PLAN 2

PLANNING APPLICATION PLN-18-0216

16338 MIDLAND HIGHWAY, PERTH

<b>Issue</b>	02 - Response to RFI
<b>Date</b>	22 May 2019
<b>Project Name</b>	Dornauf Subdivision
<b>Project Number</b>	11.105
<b>Author</b>	George Walker
<b>Document</b>

DRAFT  
 PROPOSED SUBDIVISION  
 PLAN  
 11/105 P01

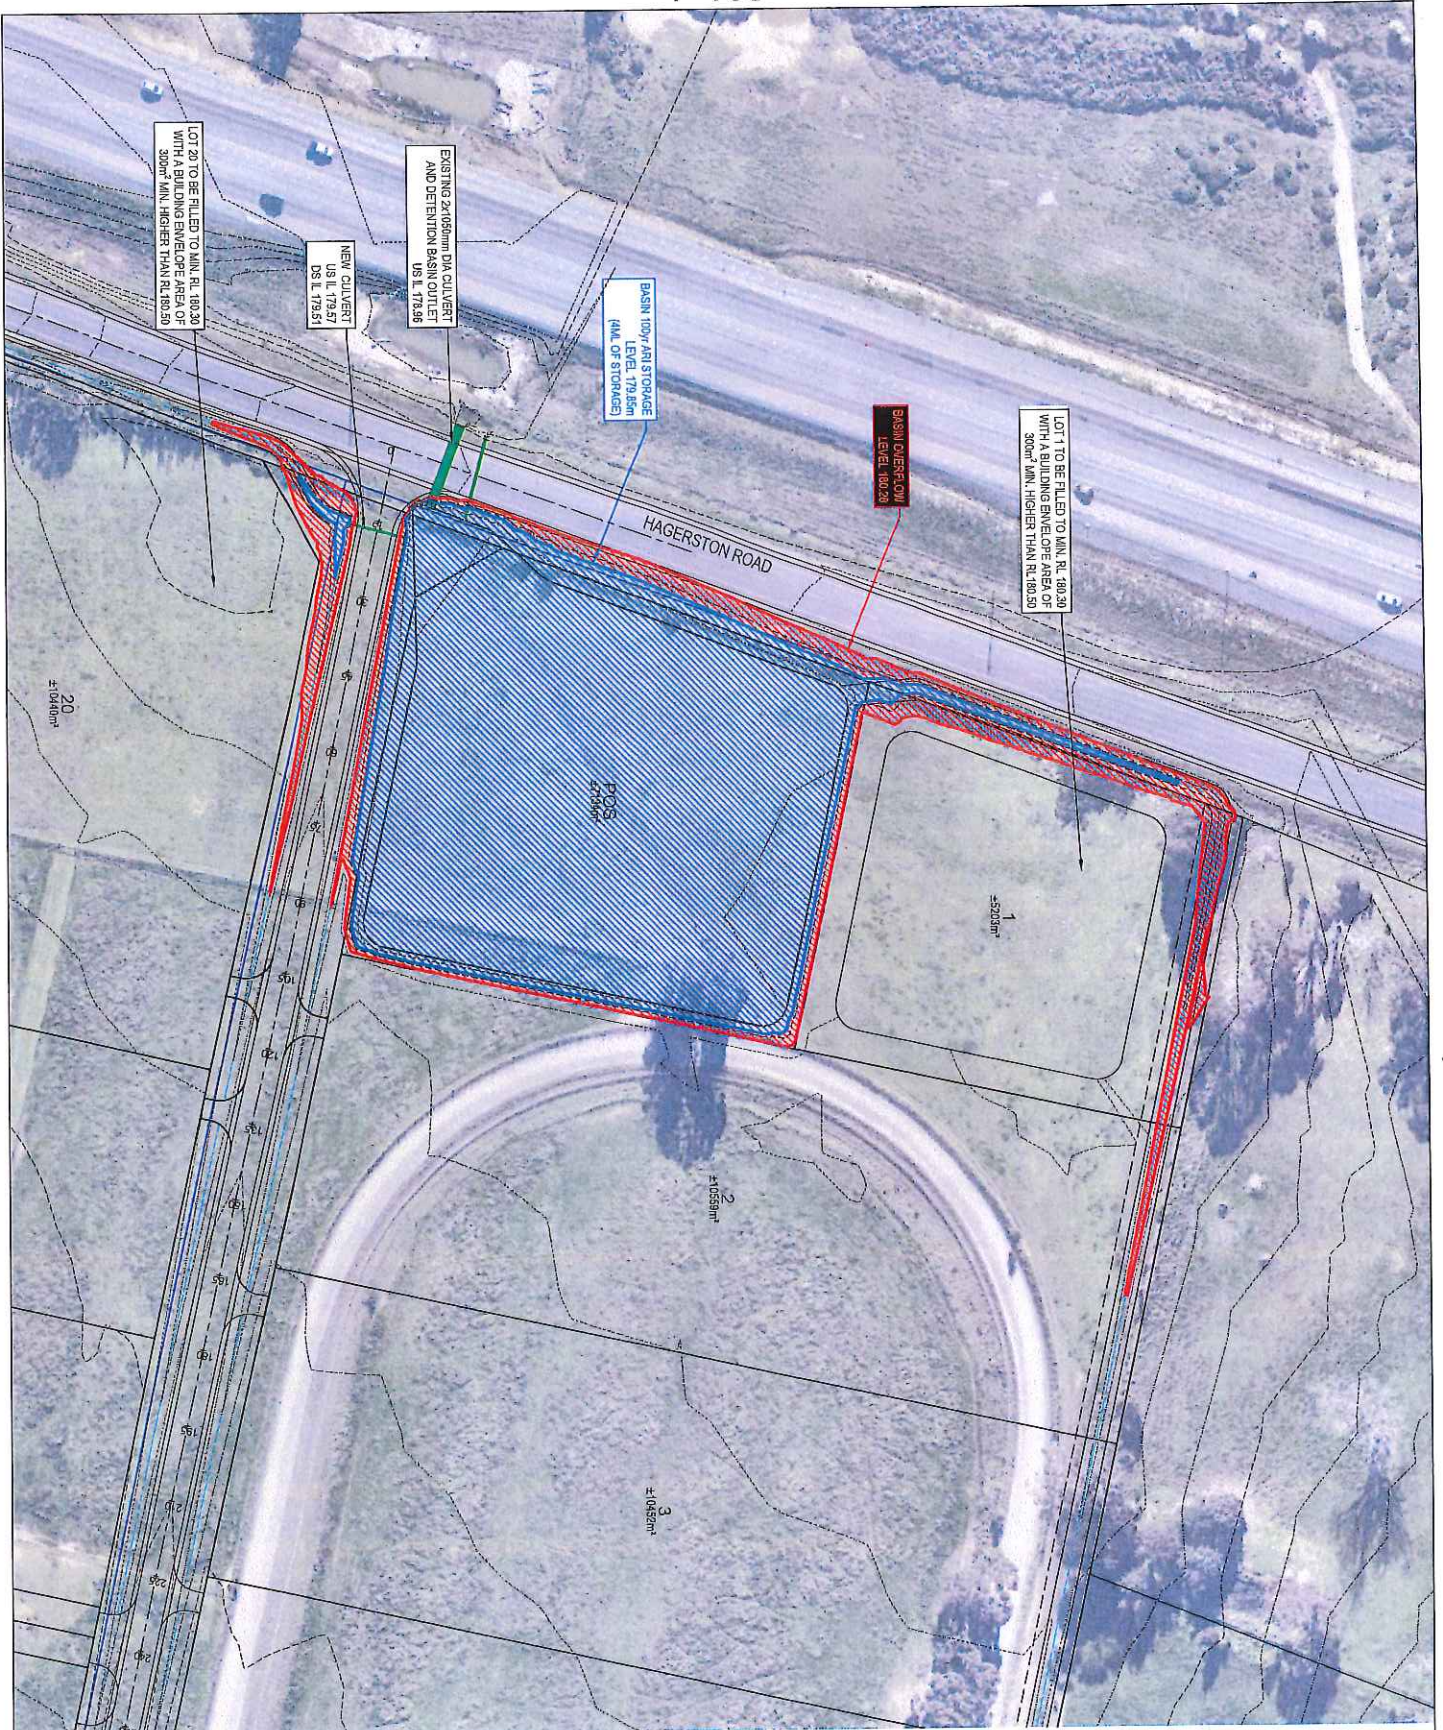
- Inclusion of 5% public open space adjacent to the old Midland Highway.
- On-site stormwater detention to limit flows from the site to the existing amount for the 1 in 100 year event.
- Removal of the perimeter cut off drains from the plans.

- Removes the concept servicing plan for water supply as we are no longer proposed to extend water to the subdivision;
- Relocates the accesses to lots 20-22 from Haggerston Road to the new access road;
- Retains lots that are less than 1ha in area.
